**Flood Control Project Maintenance  
Levee Inspections**

## Maintenance Issue Types Only, Levee Inspection Report By Mile - Spring 2019

### Lake County Watershed Protection District

Waterway	Bank	Unit Miles	Inspection Start/End	Inspector
Unit No. 01 Middle Creek	Left	3.35	04/11/2019 05/24/2019	Luz Dial

Photo 2 of 3 : UCIP\_SP\_2019\_27184\_50321.jpg

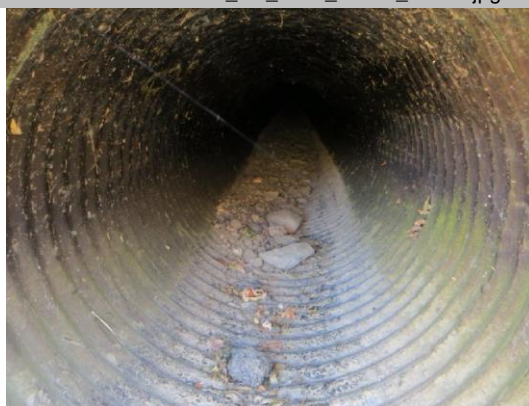
LM Start	0.24	Rating **	A/W	Issue No.	41 (cont)	
LM End	0.24	Issue Type +	Ma	Location *		
Category	Supplemental			GPS Latitude/Longitude		
				Start		End
Item	DWR UCIP LMA Responsibility			39.186794 °		39.186794 °
				-122.909413 °		-122.909413 °
DWR ID	21204					
Comment Code						
Inspector Comment						
FS_ID:27184 DS_ID:21204 EP_NO: 11484 Repair Type: No Action Needed Crossing Status: Found UCIP Comments: FIELD_STRUCT_DESC: 36-inch corrugated metal drainage pipe through the levee, 6 feet below the crown. Flap gate on the waterside (WS) end. Concrete headwalls on both ends. (36-inch pipe [HLM 0.23] retained under Automatic Board Order (ABO) issued as Permit No. 11484, 1975 - Rodney Snow). [Additional Reference(s): DWR Levee Log, 2005. USACE Sacramento O&M Manual 506.2, August 1961, (HLM 0.23)]. FS Date: 1/14/2014

Photo 2 of 3 : UCIP\_SP\_2019\_26891\_49681.jpg

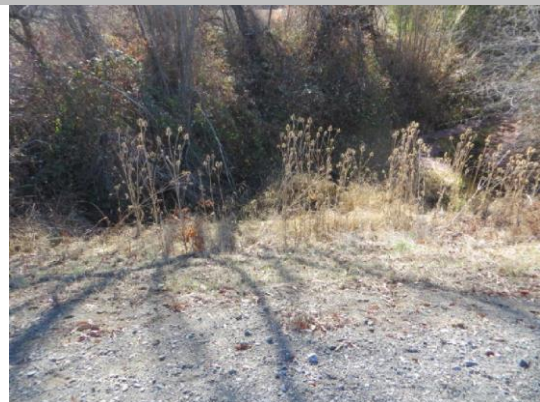
Outlet visible at concrete headwall on LS toe.

Photo 2 of 3 : UCIP\_SP\_2019\_26883\_49621.jpg

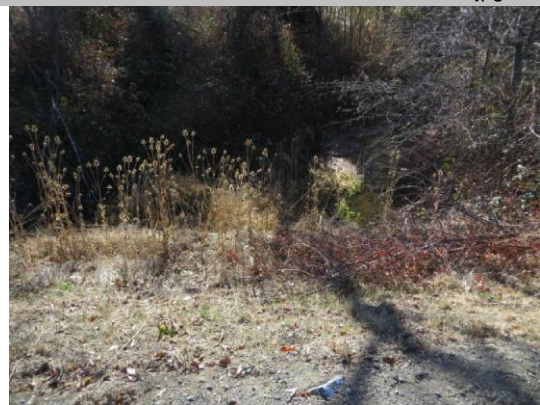
Pipe visible at concrete headwall on LS toe.
